## Commentary on the Town Centre Improvements proposed by Babergh DC and SCC Highways

The  
Sudbury  
Society

15 August 2022

## Bus Station

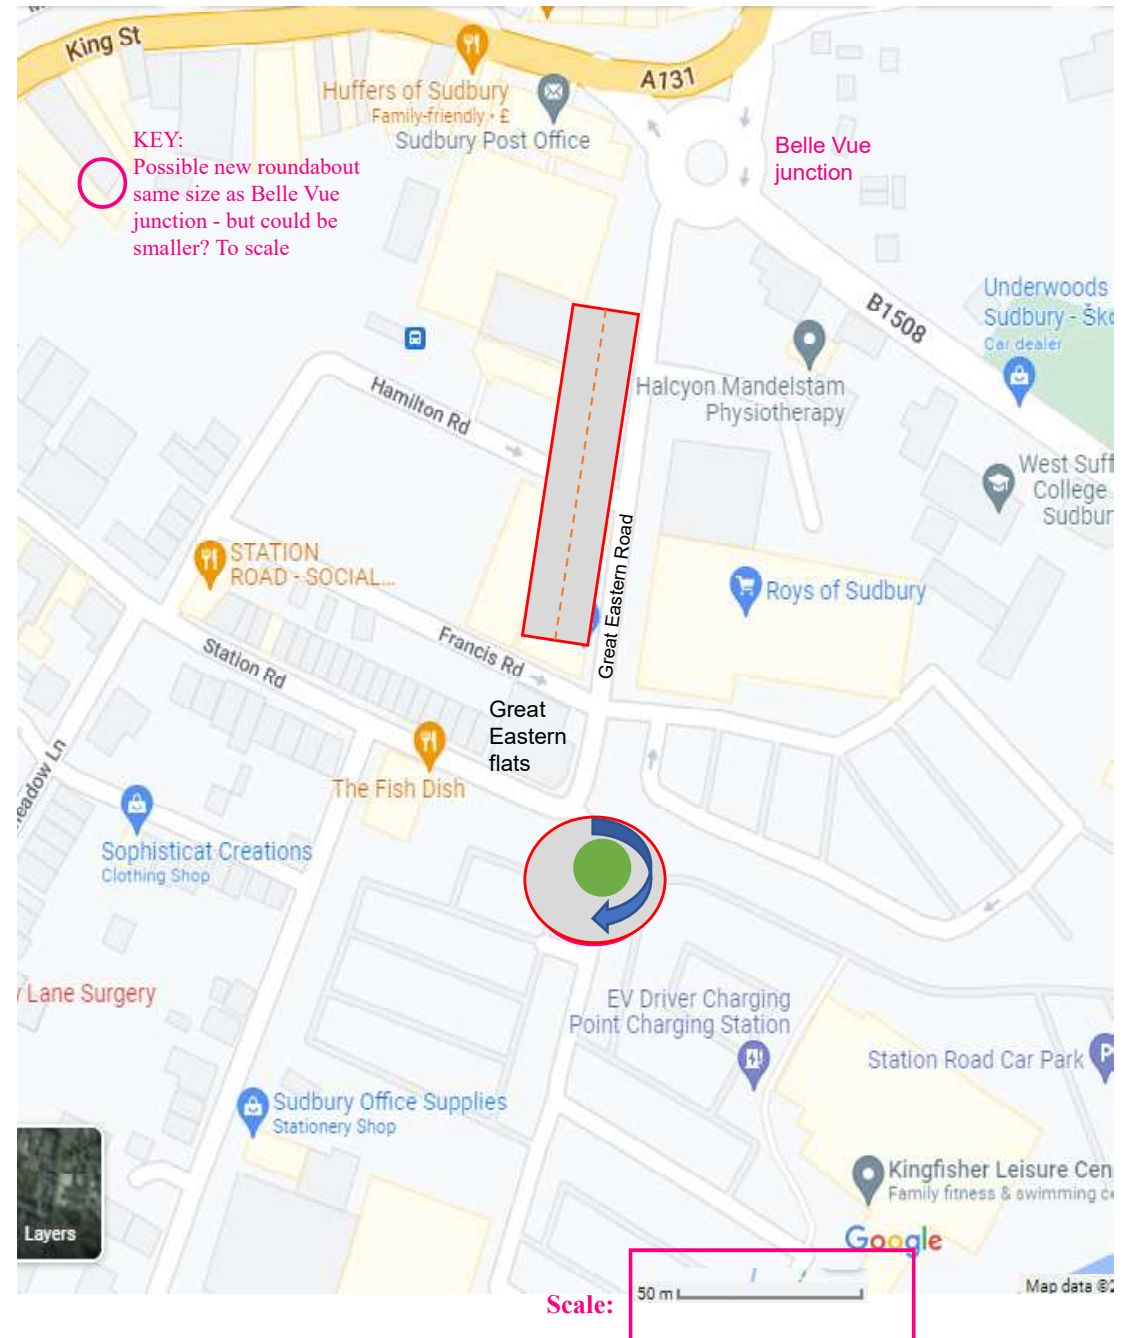
The bus station takes up far more space than is needed. We would be surprised if any more than 4 buses are there at any one time. But we believe that both visitors and towns-people need *a single point* from which buses depart. The dispersal of buses elsewhere simply will not work. If a 'bus hub' was established in Great Eastern Rd there would be no need for the bus or coach stops proposed for Market Hill.

In-bound buses can turn 180° at a new Waitrose/ Kingfisher roundabout, then drop/pick up passengers at a set of bays on the west side of Great Eastern Rd, widened by the removal of the Carpet Warehouse and other low-grade buildings.

Bus users would just get on/off their bus at this 'hub' and go on their way. Parking on Market Hill can be retained to the benefit of visitors and shops. Coaches, which are infrequent and run to no timetable, could be accommodated elsewhere, such as in Girling Street.

## Great Eastern Street

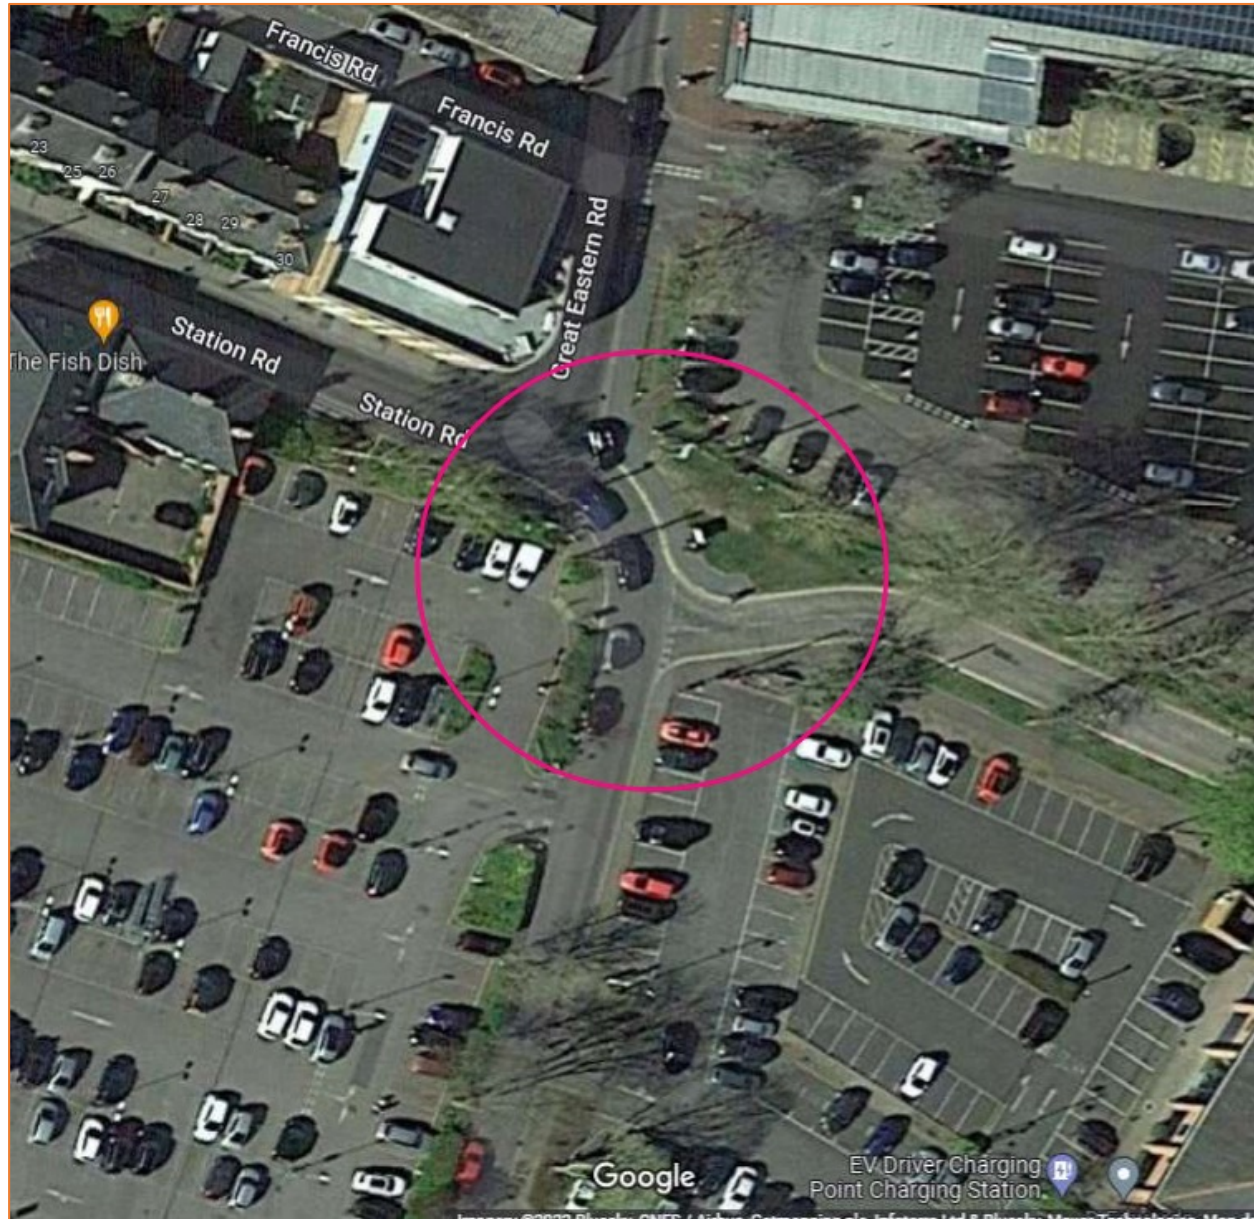
We estimate this roundabout would cause the loss of c. 20 parking spaces, a small fraction of the total nearby, and would mitigate traffic problems on this difficult corner.

It's essential for Station Road traffic to be able to reach Waitrose, the railway station, the Kingfisher and the new surgery complex *directly*.

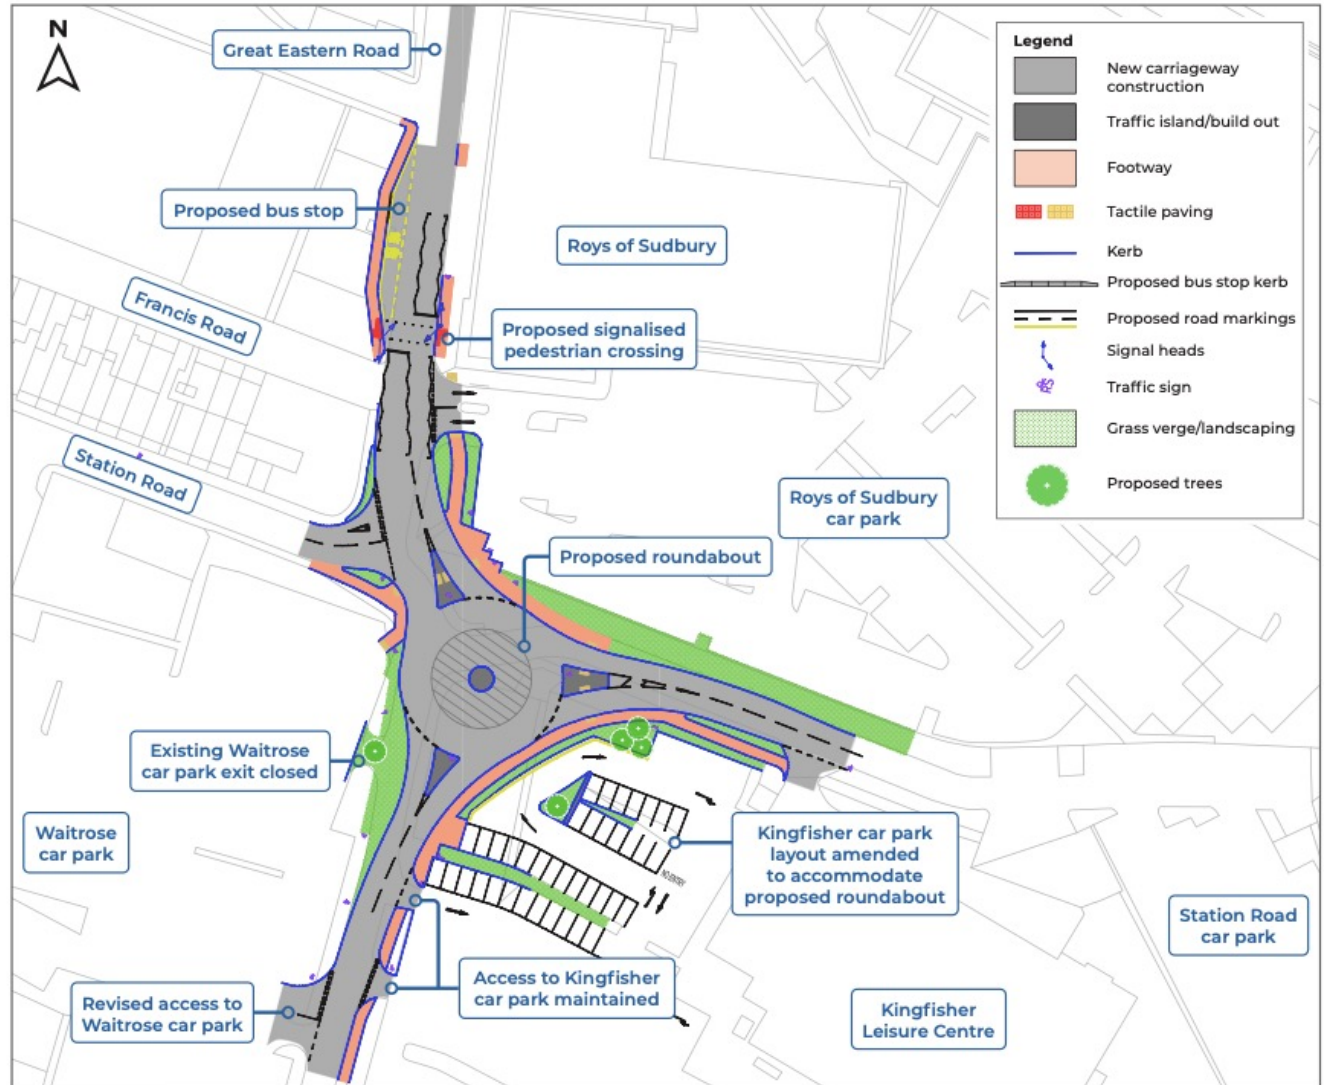
This proposal sends all such traffic up to the Belle Vue roundabout and back down again. We hope SCC Highways are not serious.

## Ingrams Well Road

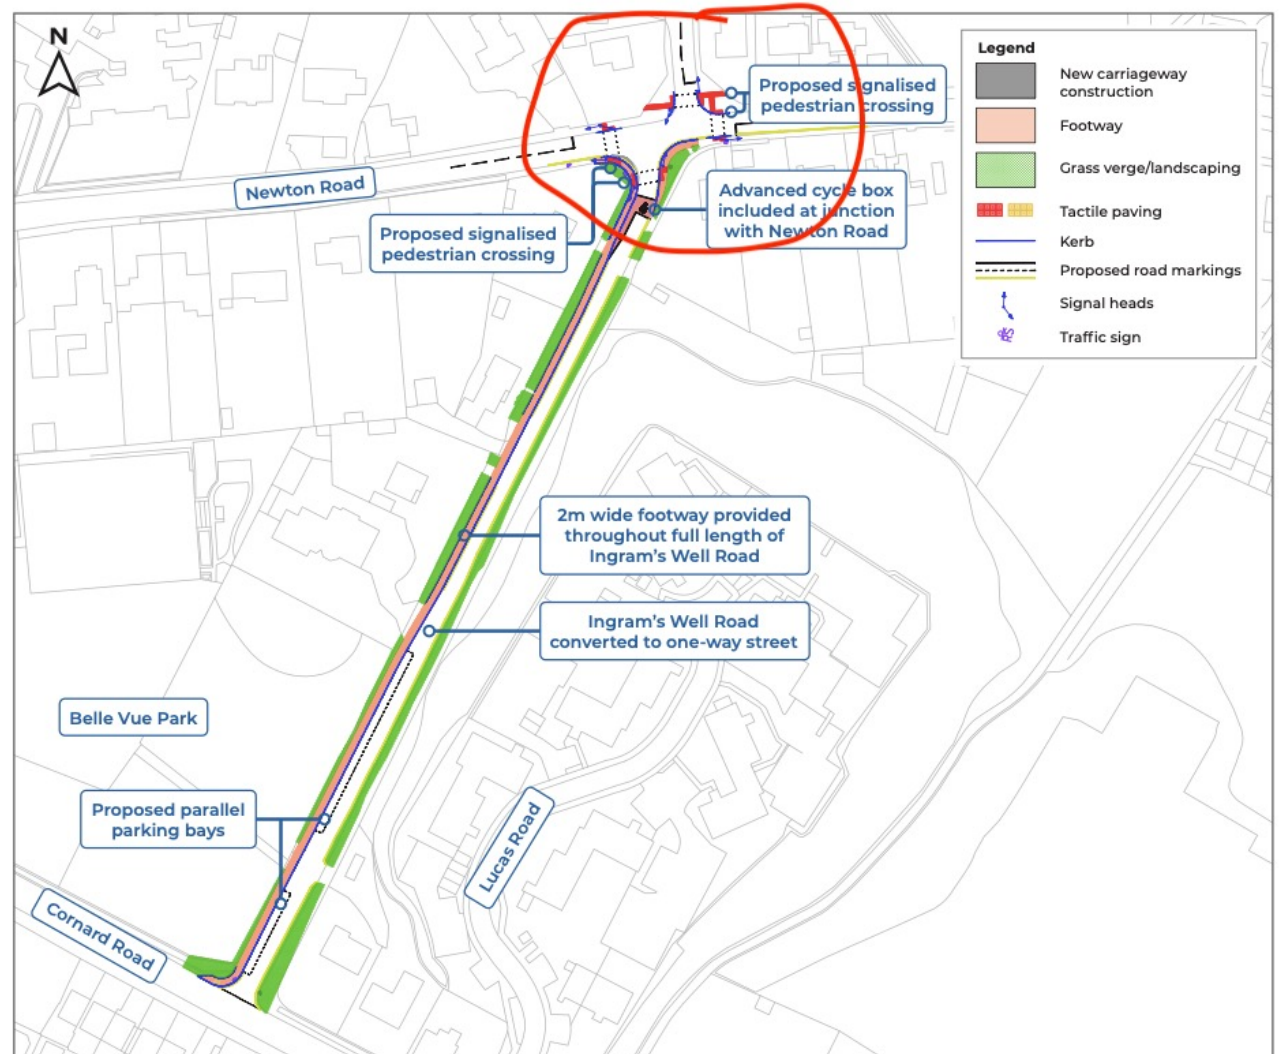
We see very little merit in this plan in proportion to the probable cost, which would be better spent elsewhere.

Why the conversion to a one-way street uphill. This will mean loss of parking in the road for park users or for those who work in Sudbury and avoid long-stay charges.

Pedestrian volume, which is very low, does not warrant any lights at the Newton Road Junction, let alone *two* pairs, which will add delays to the main route in and out of town to and from the south.

Granted, the exit from the road to Newton Road is tricky. One solution would be to cut back the grass bank to improve visibility.

## Girlinging Street

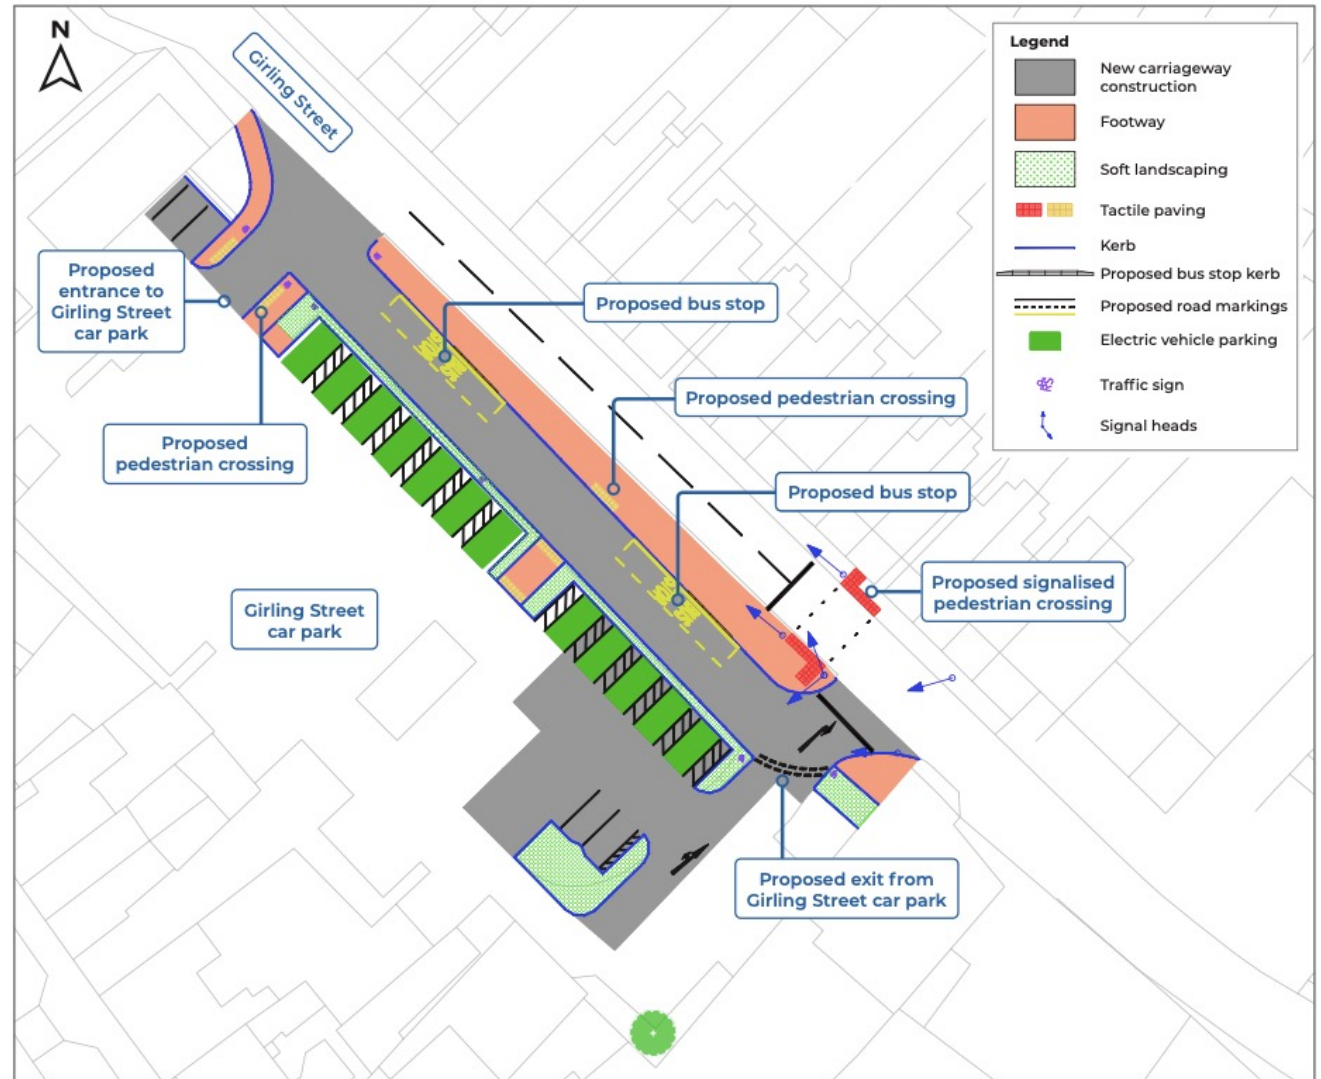
The proposals do not mention the loss of available parking spaces and this must be quantified. If the concept of a bus hub is feasible, no bus stops here will be necessary.

The pedestrian crossing specified here is completely unnecessary as it leads to nowhere significant and there are already two light-controlled crossings along the street nearby. Very few pedestrians can be seen using this footway. A third crossing will just add to congestion on what is supposed to be a through route for traffic.

The loading arrangements for Iceland and adjoining shops are ignored and, with cooperation between shop owners, a matter which causes regular congestion could be improved.

## East Street

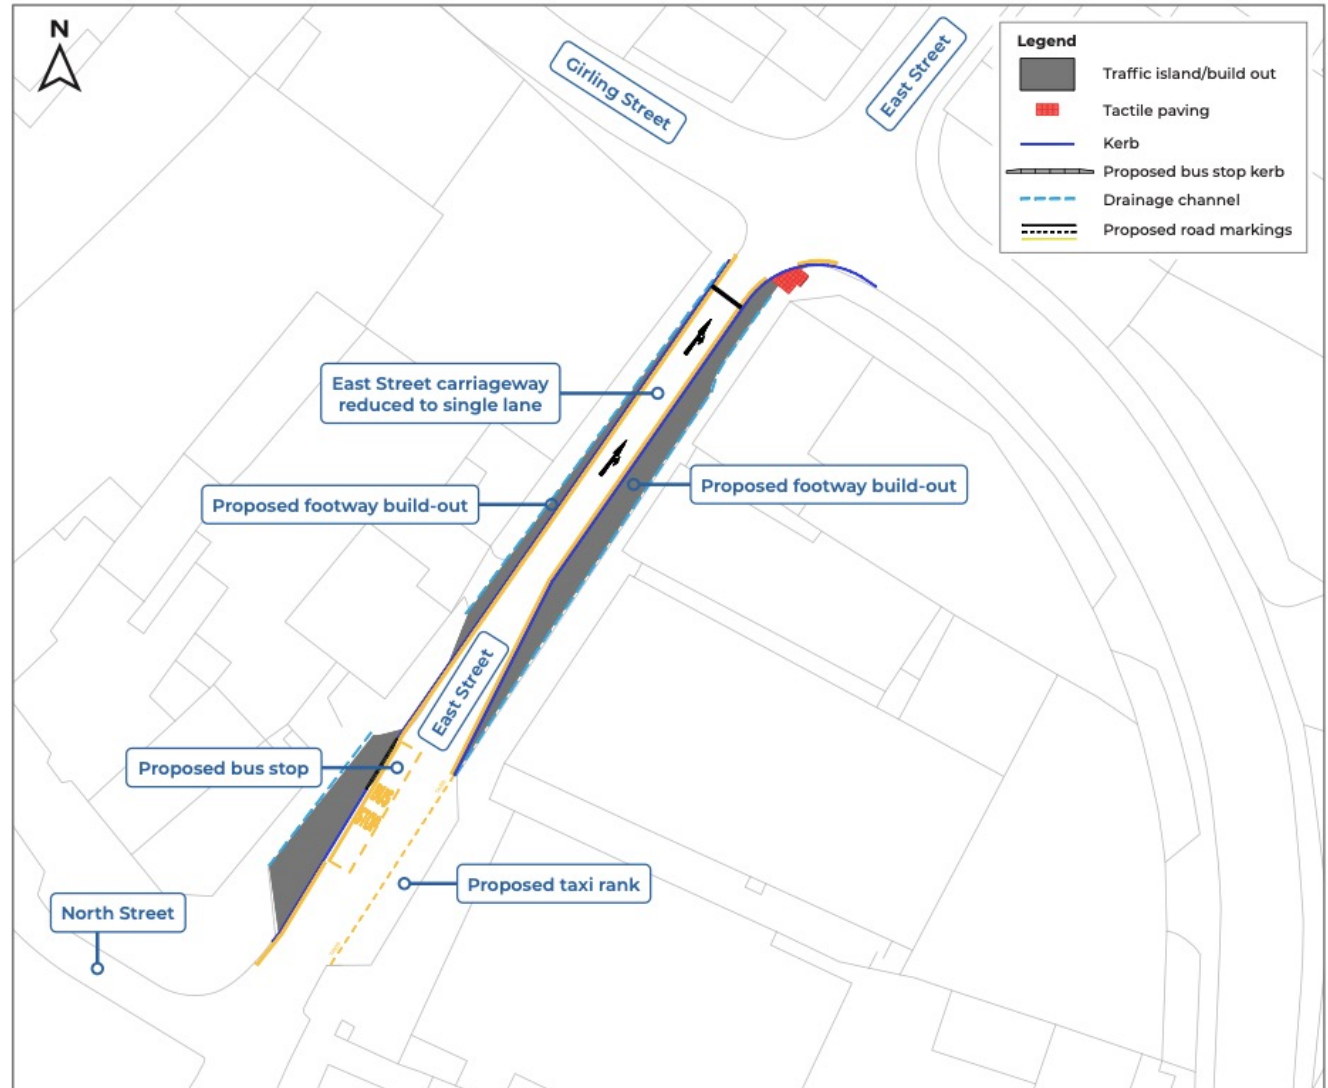
This proposal should be abandoned. The road is already very congested when deliveries take place with two lanes. And if it is reduced to a single track anyone wanting to turn right will cause traffic to back up. At present outgoing traffic can run at the same time as traffic coming in from out-of-town. This junction is one that will bear the brunt of increased flows from Chilton Woods.

We are told that it has to become single lane to allow buses to turn right into Girling Street. This is an infrequent event and a bus can do this already simply by straddling both lanes as they approach the lights.

Broadening the south side pavement is also pointless. Few people walk along this side of the street – they mostly use the north side to make use of the light-controlled crossing.

## Market Hill, planting

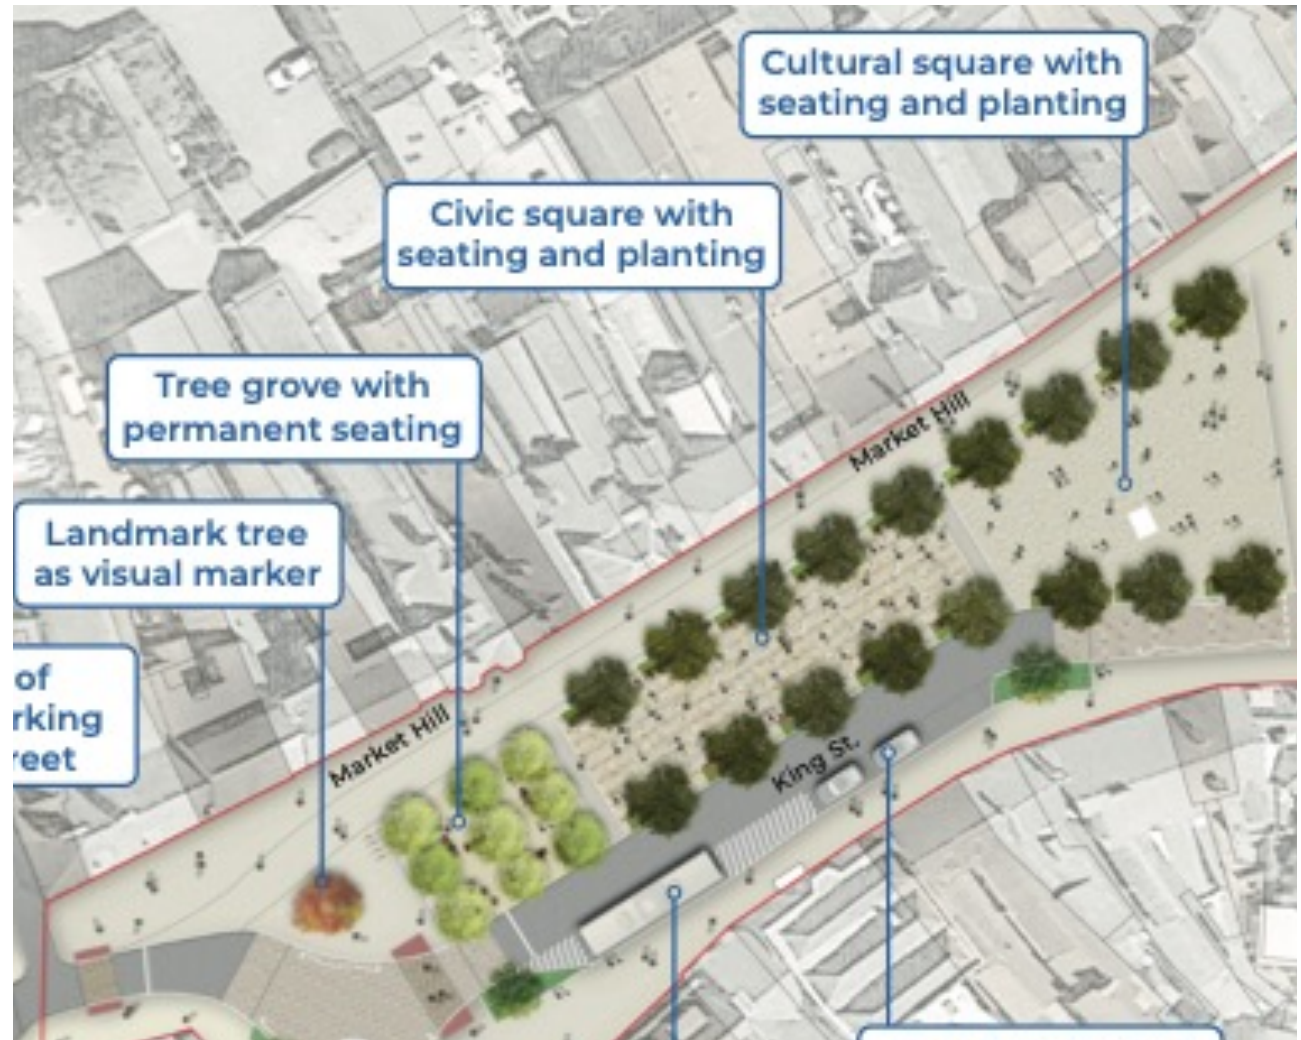
Any more trees of any kind should **on no account** be planted on Market Hill, especially not 'landmark' trees, which will block views of St Peter's and change the character of this central space.

If planted in the ground their roots will affect the reportedly complex network of underground services here.

If planted in tubs they will need after-care, watering, pruning and weeding. In either case they will generate a great deal of leaf clearance and we doubt such council services will be available at the standard of care required.

Please just forget this element of the plans. Any new planting can be confined to the 'high hedge' proposed on the following slide.
